## SAN RAFAEL CITY COUNCIL AGENDA REPORT

### TOPIC: TRANSIT CENTER RELOCATION DRAFT ENVIRONMENTAL IMPACT REPORT

SUBJECT: RESOLUTION APPROVING AND AUTHORIZING THE MAYOR TO SIGN A LETTER TO THE GOLDEN GATE BRIDGE, HIGHWAY & TRANSPORTATION DISTRICT SUMMARIZING CITY COMMENTS ON THE SAN RAFAEL TRANSIT CENTER RELOCATION PROJECT (SRTC) DRAFT ENVIRONMENTAL IMPACT REPORT (DEIR); FILE P21-012

Figure 1. View upstream of Irwin Creek from 4<sup>th</sup> Avenue at proposed site.

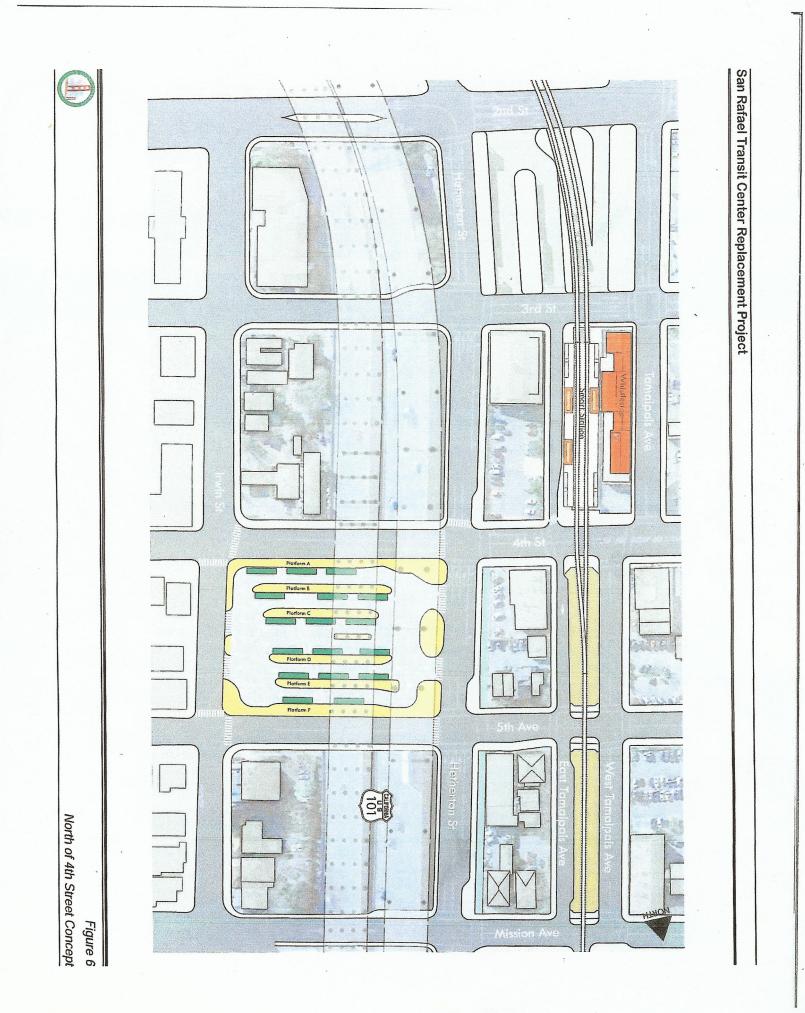
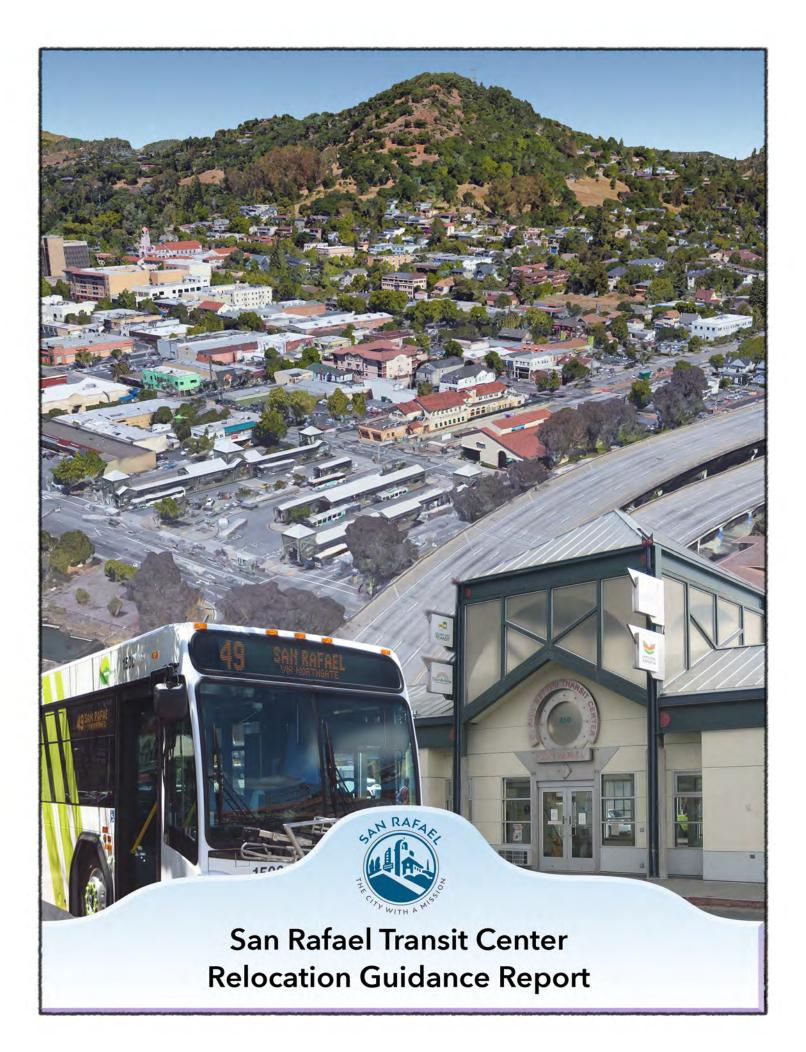
During our site visit, Nicole confirmed that the drainage was a jurisdictional waters regulated by the RWQCB and that any fills or modifications to this reach of the creek would be subject to their review and authorization. She explained that the preferred policy of the RWQCB is to avoid modifications to jurisdictional waters. Where avoidance is not feasible, that they then prefer that direct and indirect impacts be minimized, and that compensatory mitigation be provided where impacts are unavoidable. That as part of the review process performed by the Corps and RWQCB, a finding must be made that the proposed modifications to jurisdictional waters are the Least Environmentally Damaging Practicable Alternative (LEDPA).

We reviewed the preliminary schematics for the Transit Center Relocation prepared by the Golden Gate Transportation District (see attached plans), which show the entire reach of Irwin Creek across the site to be culverted. Nicole indicated in reviewing the plans that a proposal to culvert the entire reach of Irwin Creek across the site would be unacceptable by the RWQCB. This is because the RWQCB could not make necessary findings that culverting the entire reach was the LEDPA available, and that there was no alternative for the Transit Center Project that didn't either completely avoid the creek or at most had a much more limited impact by culverting just a portion of this reach to provide access over it, such as a bridge structure. We discussed possible options for limiting potential impacts and providing compensatory mitigation for any unavoidable impacts. However, this would depend on final design, the extent of any fills or other modifications to regulated waters, and other factors that can't be fully understood or addressed at this time given the preliminary nature of the proposed project. We indicated to Nicole that at some point the City intends to present more refined plans at a Marin Project Coordination Meeting in the near future.

With appropriate refinement to the proposed Transit Center site under the I-101 overpass, use of this location does look possible from a regulatory agency permitting standpoint based on the preliminary information we received from RWQCB. Following refinement of project plans to minimize fills to the Irwin Creek channel and adhering to standard Best Management Practices would greatly reduce and control potential impacts to regulated habitat. Where permanent impacts could not be avoided due to fills and shading associated with a new bridge structure, compensatory mitigation could then be achieved by creating replacement habitat or other approaches acceptable to the regulatory agencies. Opportunities for achieving compensatory mitigation for any fills to the Irwin Creek channel may be available downstream, elsewhere in the watershed, and at other locations in East Marin County.
